13 July 2011

Section 75W Modification to MP 10_0145 – Design Changes
Sydney Showground Main Arena Redevelopment, Sydney Olympic Park

Illustration of revised Stage 1a

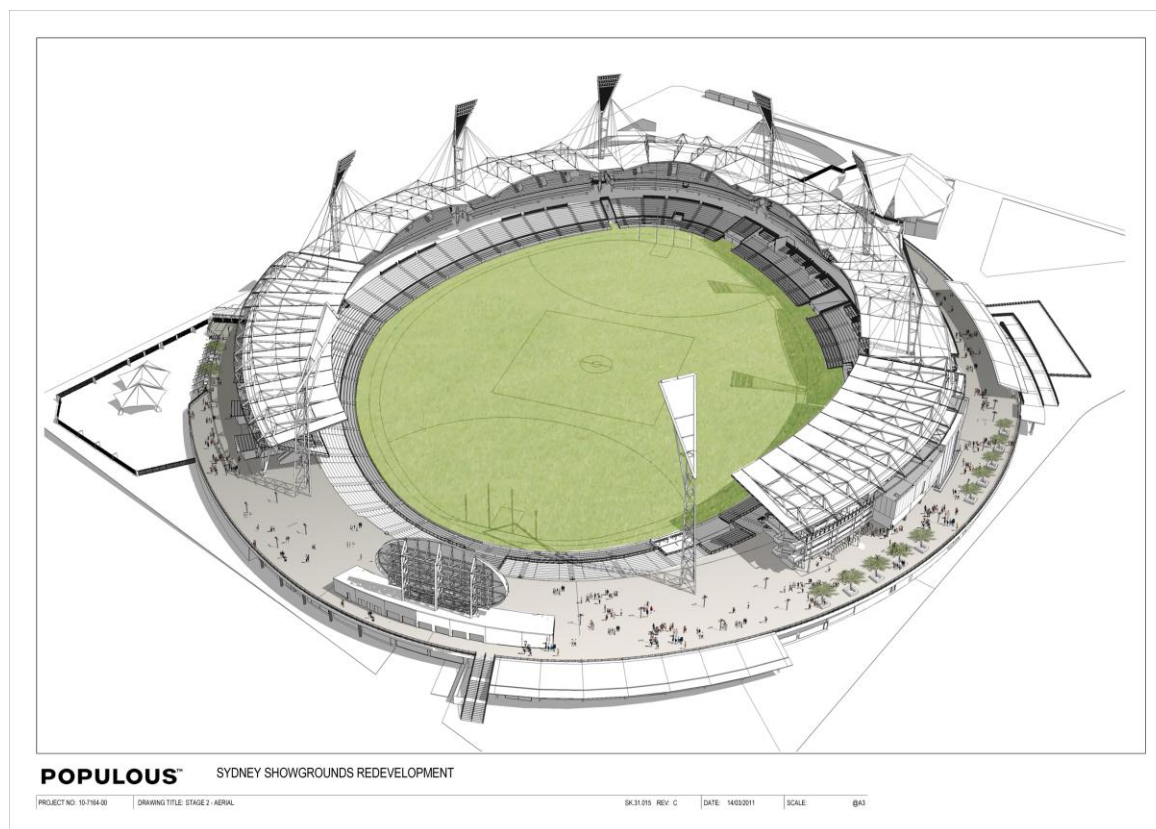
As a consequence of resolving the design considerations under Condition B1 with SOPA, the approved scheme has undergone changes to the scope of the design, broadly entailing:

- Removal of the north stand and a reduced length / extent of the south-eastern stand.
- Removal of the grassed spectator area.
- Rationalisation of amenities, bar / food areas and the like, redesign of scoreboard.
- Capacity numbers are generally similar, if not marginally less, than the approved capacities.

Overall, the SOPA approved design scheme arising from Condition B1 represents a similar design to the approved scheme but with generally reduced length/extent to the seating stands and their associated roof forms for Stage1a.
